Cogentrix Quail Brush Generation Project - Docket Number 11-AFC-3, Data Request Responses to Set 6: Data Requests 77 through 86

QUAIL BRUSH GENERATION PROJECT (11-AFC-3)

**Responses to Energy Commission Staff's Data Requests
77 through 86**

FIGURE 1

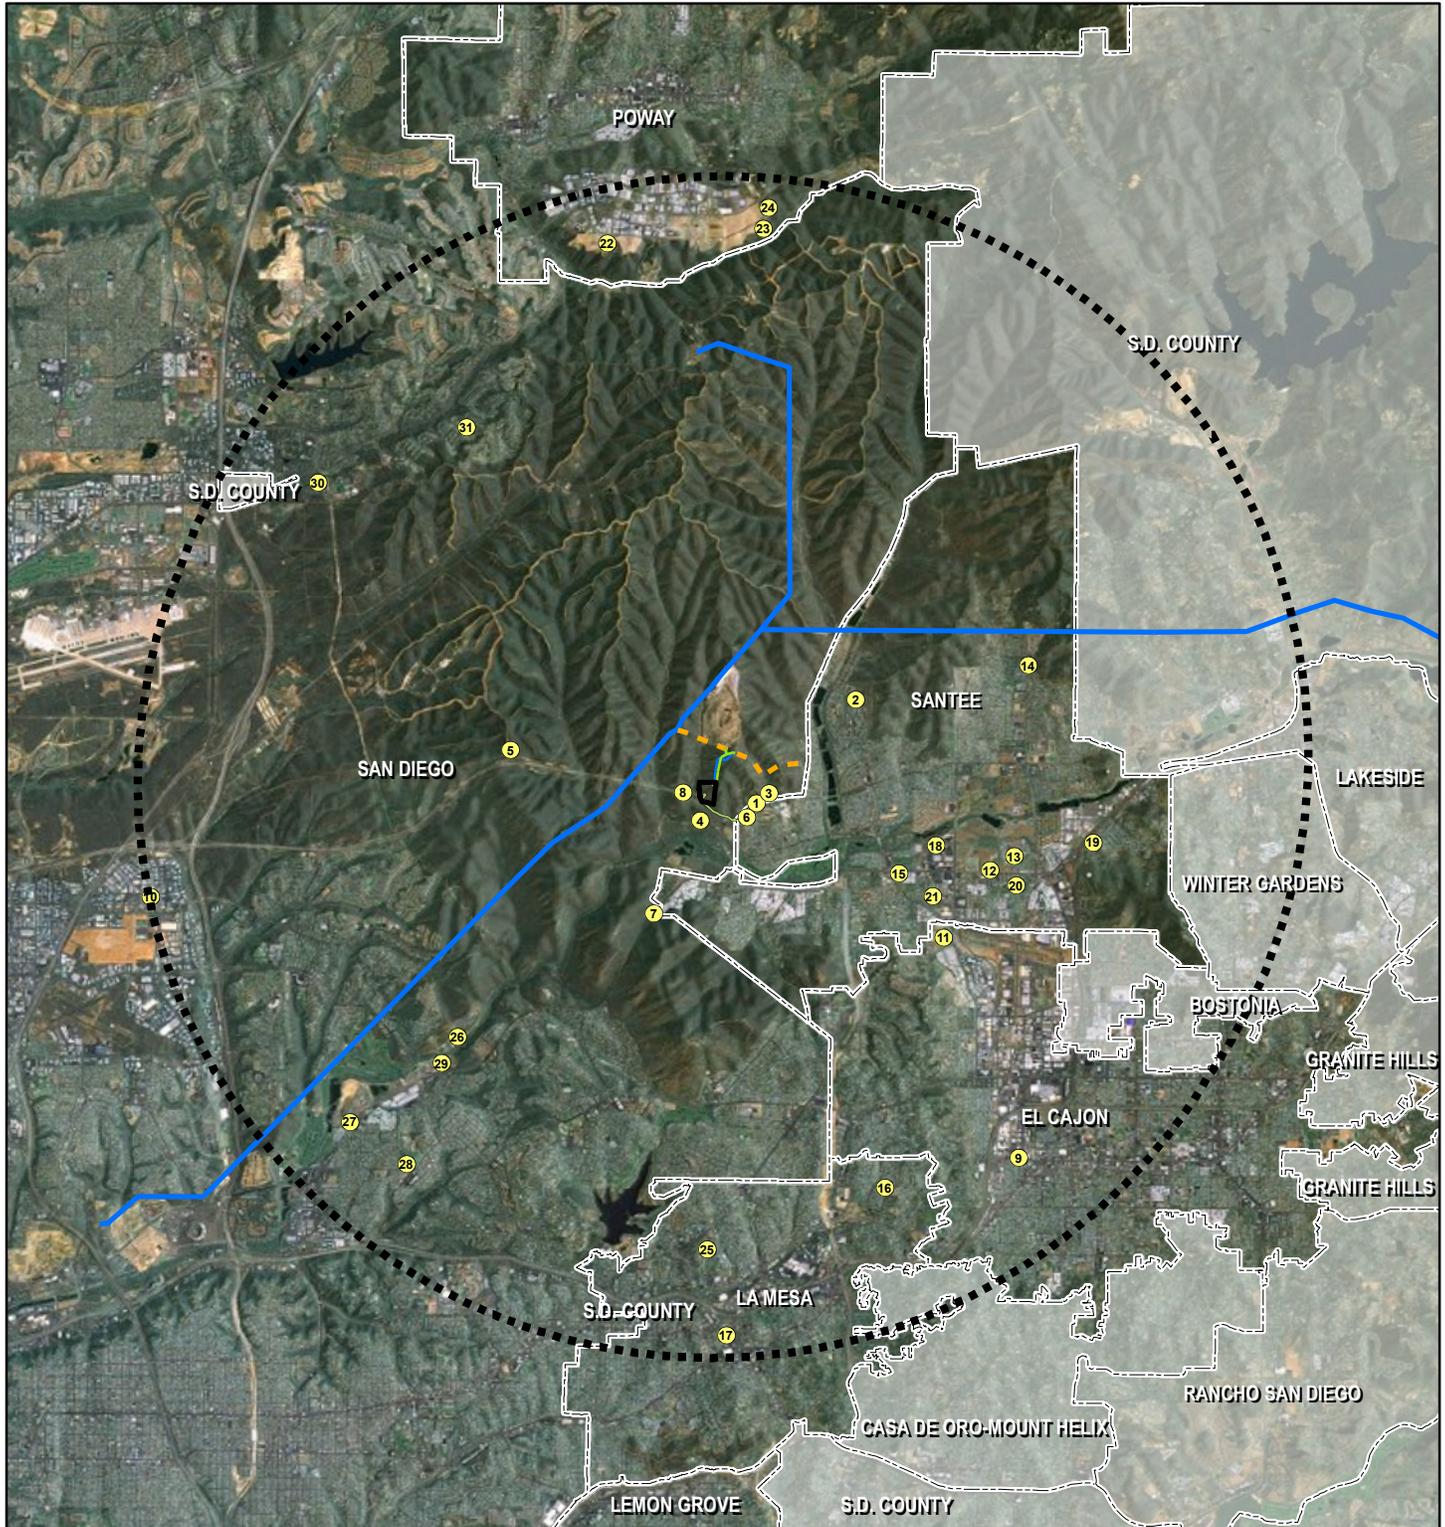
78. Data Request: Using Google Earth or a similar source, please provide an aerial photo of the 6-mile radius from the QBGP. The photo should identify the location of the proposed QBGP site and identify the location of each project on the populated Master Project List, produced in response to data request #77, above. Please also provide the GIS files and the kmz file types for the populated aerial photo, if available.

79. Data Request: For consideration of cumulative impacts in the area of Socioeconomics, please provide a list of industrial and commercial projects located in San Diego County, and the cities within the county, that could have construction schedules overlapping with the QBGP. Please provide a list of residential development projects located in the cities of Santee, El Cajon, La Mesa and San Diego. The list of projects should be reported in the same format as shown in Attachment "A", the Master Project List. If the information is available, please identify the amount and type of workforce needed by each project during construction and operation.

Please provide a comprehensive map showing the location of these projects and provide the GIS files and the kmz files if available.

Figure 1 is an aerial photo that identifies the location of the proposed QBGP site and each project listed on Attachment A. The GIS and .kmz files are provided electronically as an attachment to this submittal.

Air Quality Response: Per the Applicant’s response to DR #77 and DRs #84 and #85 only one potential stationary source is submitted for plotting or display on the requested map, i.e., this source is the Sycamore Landfill facility. The location coordinates provided are for the approximate center of the landfill site which lies north of the QBPP site. This data is as follows:

Site Name: Sycamore Landfill Facility (SLF)
UTM Coordinates: 497488 mE, 3636077 mN, Zone 11
Approximate Distance from QBPP site: 4500 ft.
KMZ file: Sycamore LF.kmz (attached)
Project #1 on Master Project List (Attachment A)

As stated above in DR #77, Figure 1 is an aerial photo that identifies the location of the proposed QBGP site and each project listed on Attachment A. The GIS and .kmz files are provided electronically as an attachment to this submittal. A separate map, as requested in this DR #79, is not provided because no projects were identified using publically available information that meet the criteria described above.
